RECEIPT DATE: 7/5/17 **ONSITE SEWAGE DISPOSAL SYSTEM** P 561447
 APPROVAL DATE: 07/18/17 **PERMIT: CONSTRUCTION** A _____
 PROPERTY ADDRESS: 11041 Fuzzy Hollow Way
 SUBDIVISION: Melchior Property LOT: 4 TAX ID: 03-596008
 CONTRACTOR: Hatfield's Equipment EMAIL: ken@hatfieldsequipment.com
 CONTRACTOR ADDRESS: P.O Box 519, Annapolis Junction, MD 21771 PHONE: 301-490-4289
 PROPERTY OWNER: Williamsburg Group EMAIL: marinamorrois@williamsburgllc.com
 OWNER ADDRESS: 5485 Harpers Farm Road, Columbia, MD 21044 PHONE: 410-997-5800
 SEPTIC TANK SIZE (GALLONS): 2000 TANK MANUFACTURER: Mayer Bro, Inc.
 PUMP MODEL: NA PUMP SIZE NA PUMP TANK CAPACITY: NA

ON-SITE SEWAGE DISPOSAL SYSTEM DESIGN PLAN

MELCHIOR PROPERTY
 LOT 4
 11041 FUZZY HOLLOW WAY

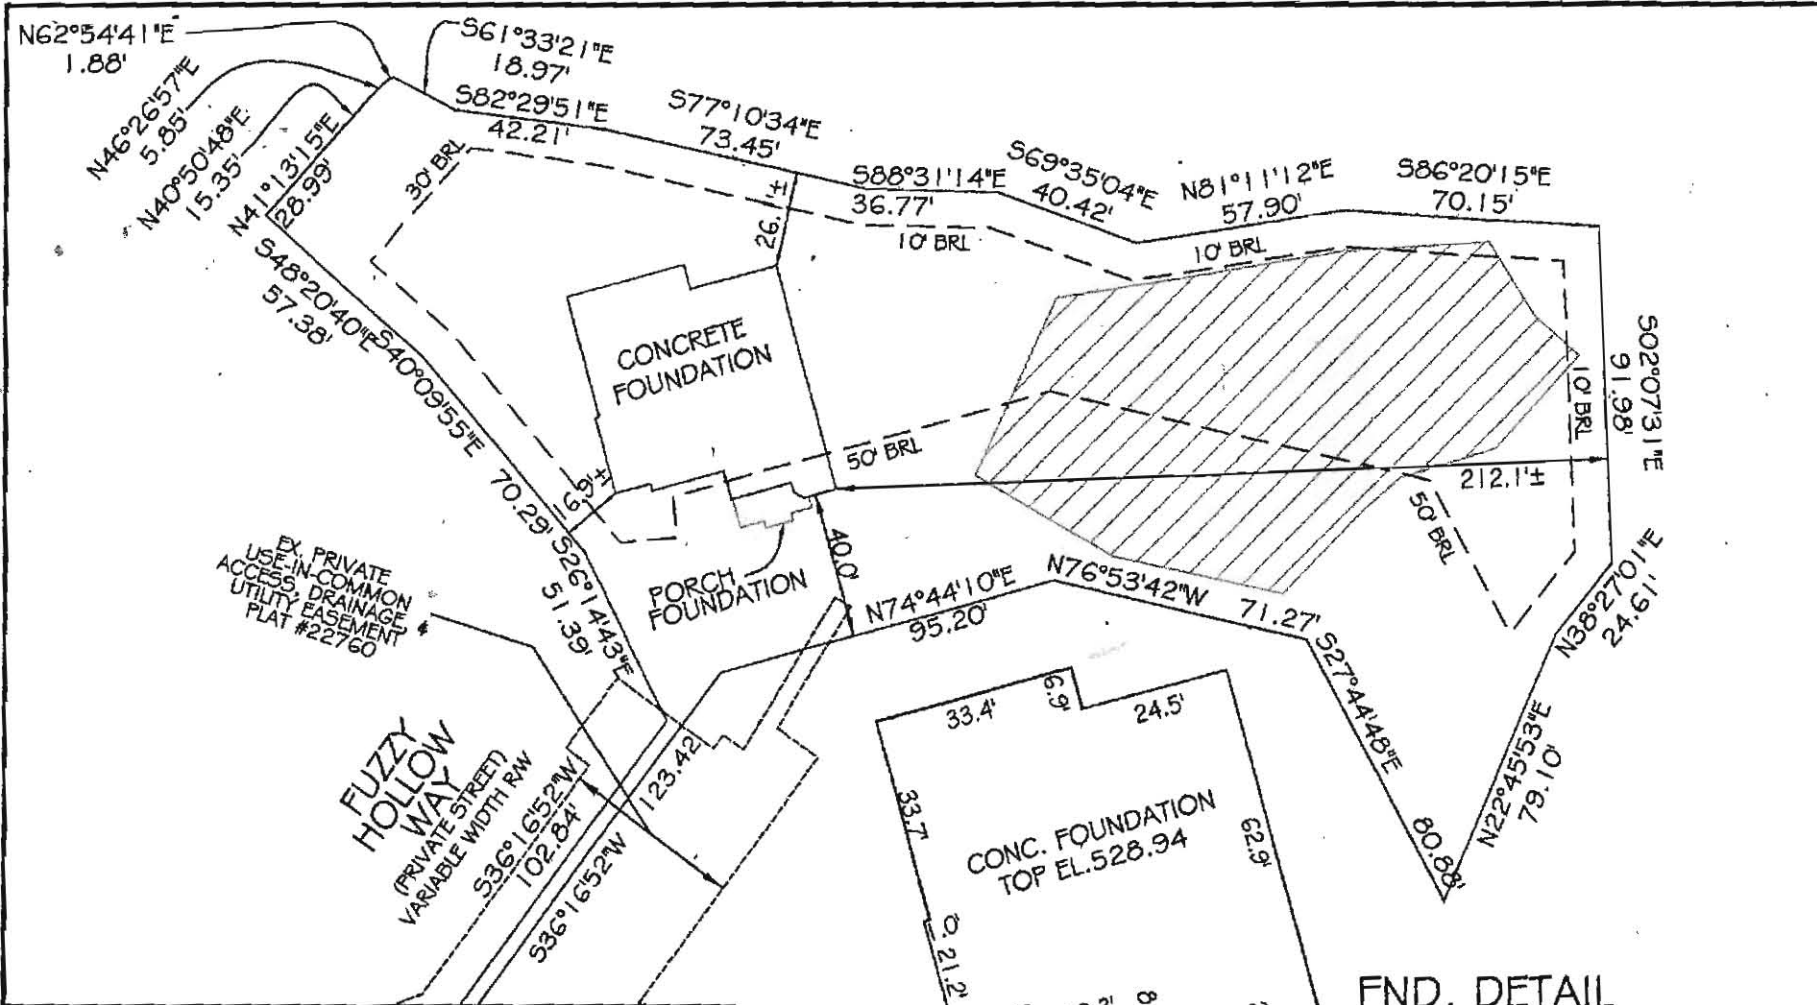
07/07/17 Septic area + trenches staked. D box + covers staked. Checked the ^{topo} height of trenches. ^{marked the trenches} Advised ^{marked the trenches} battfield to use laser level during construction for the area w/ fill towards the house. ~~At~~ Commence Trench construction from Distal end or from second trench stake (f)

07/14/17 On site after installation of tanks. ~~had~~ ~~removed~~ ~~inlet~~ ~~baflle~~. Approved to backfill house connection. Contractor did not start on far end of trench or from second trench stake, used laser level + marked pipe. Install lower trench 1st. Added ~10' on to the back of the trench. Upper trench markings erased during construction. Fines mixed w/ gravel from construction. Sch 40 PVC Silver line 4" Non Pressure

07/17/17 On site for completion. Took speed level of d box. Approved to backfill (f)
